Grand Junction Regional Airport Authority

TOPIC:	Appeal the Proposed Total Maximum Daily Load Water Quality Standards Proposed by the Colorado Department of Public Health and Environment		
PURPOSE:	Information <input type="checkbox"/>	Guidance <input type="checkbox"/>	Decision <input checked="" type="checkbox"/>
RECOMMENDATION:	To formally join the community appeal, led by Mesa County, against new proposed Total Maximum Daily Load water quality standards proposed by the CDPHE for the Grand Valley.		
SUMMARY:	<p>As part of the federal Clean Water Act, Section 303(d), states are required to periodically submit to the EPA a list of waterbodies that are impaired. The Colorado Department of Public Health and Environment (CDPHE) Water Quality Control Division proposed regulations for the Grand Valley establishing Total Maximum Daily Loads (TMDLs) that will determine the maximum amount of a pollutant that a waterbody may receive and still maintain water quality standards.</p> <p>A draft of the proposed TMDLs was issued in April 2021 by the CDPHE. The City of Fruita, City of Grand Junction, Grand Valley Water Users Association and Mesa County responded to the proposed standards on April 3

Figure 1. Indian Wash Example for GVWUA.

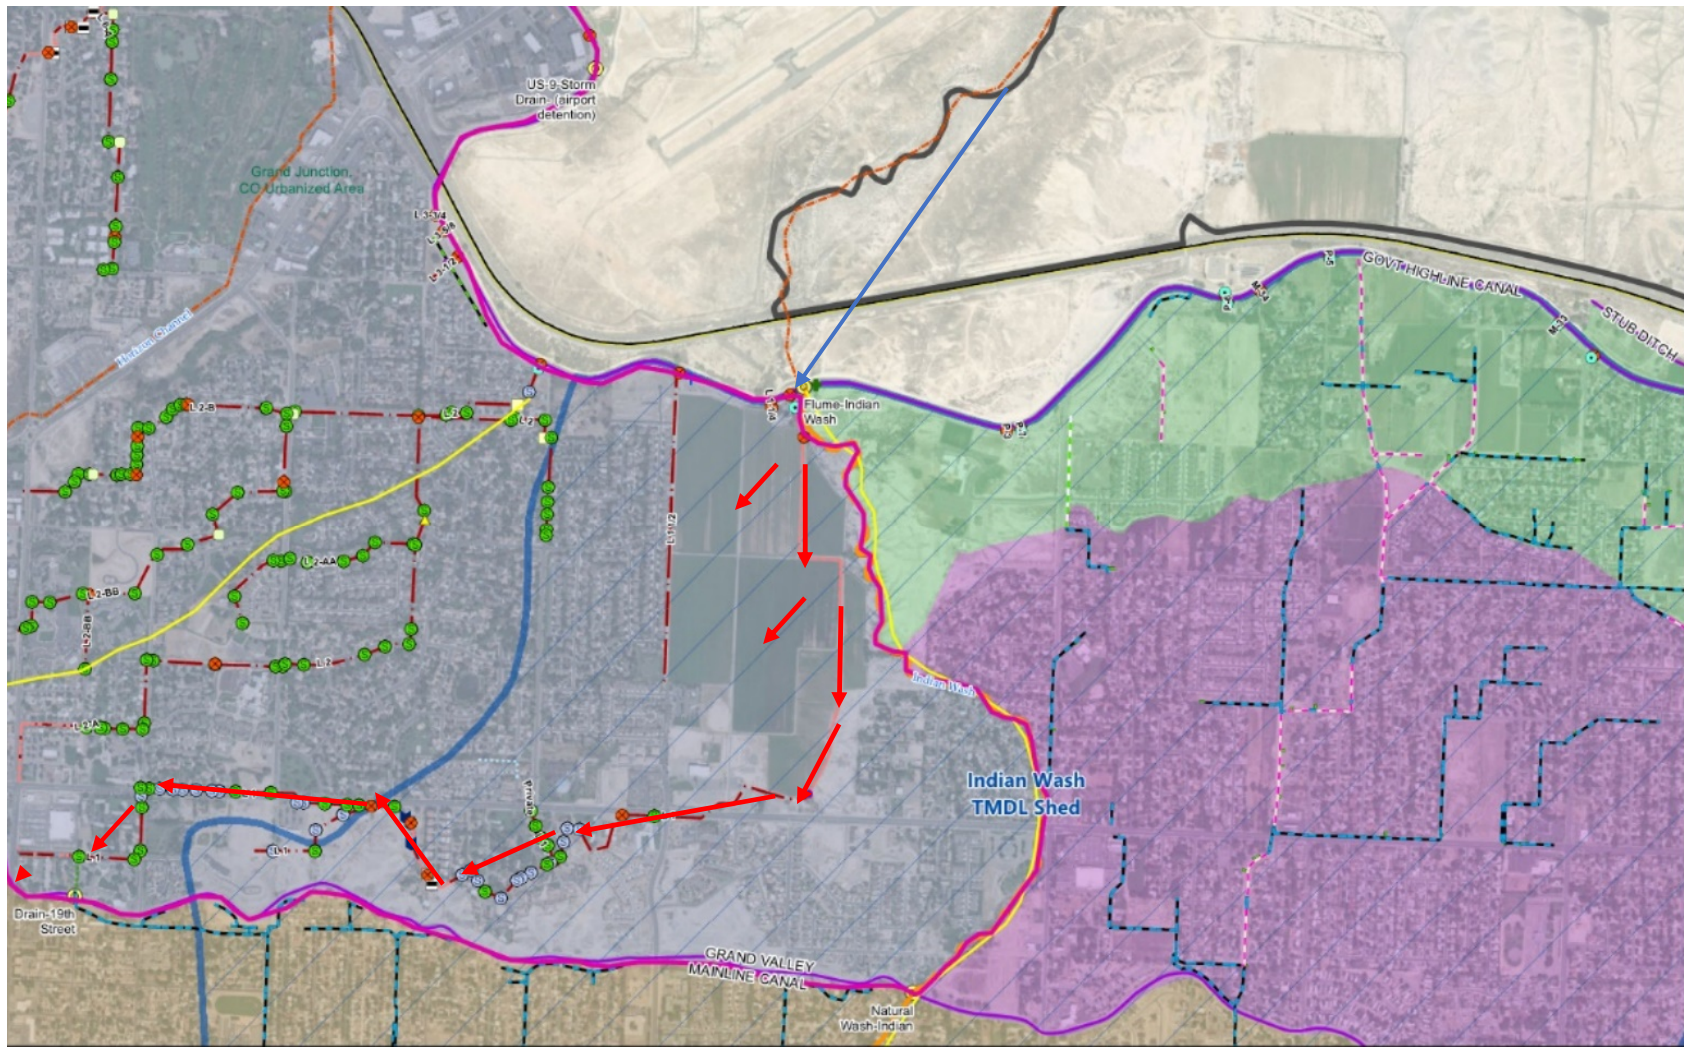
The following explanation of GVWUA's water delivery near Indian Wash is just one example of the inaccurate delineation of the sources of impairment and misrepresentation of them as a WLA.

Figure 1 shows the diversion of water from the GHC and flowpaths. Note there is a ridge to the east of the pink lateral (running north and south, immediately after the diversion) that keeps the water to the west, not discharging to Indian Wash.

- Red circles represent points of diversion off the GHC
- The yellow circles represent the location where Indian Wash goes under the GHC (no comingling of GHC and Indian Wash)
- Water is applied to the farm fields, which slope to the west/southwest or conveyed in the lateral represented by the pink and red lines that deliver water to the southwest (red arrows).
- This water ultimately travels to the west, where it is used to irrigate lands and ultimately returns to the Grand Valley Irrigation Canal (red arrows).
